Maule Aircraft Corporation

Service Letter #22

Subject: Electrical System

Models Affected: M-4-180 and M-4-220 series aircraft.

ELECTRICAL SYSTEM SCHEMATIC

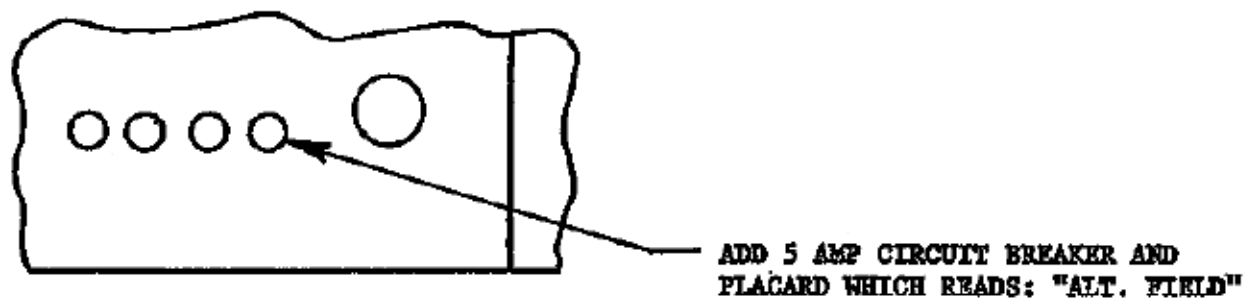
It has become necessary to install a 5 amp. circuit breaker for protection of the Alternator field wire.

This service letter applies to aircraft equipped with 5106 Alternators only.

- 1 ea. MP-1600T-5 5 AMP Circuit Breaker
- 1 ea. "ALT. FIELD" Placard
- 1 ea. 16 GA. Wire (#14 - #15)
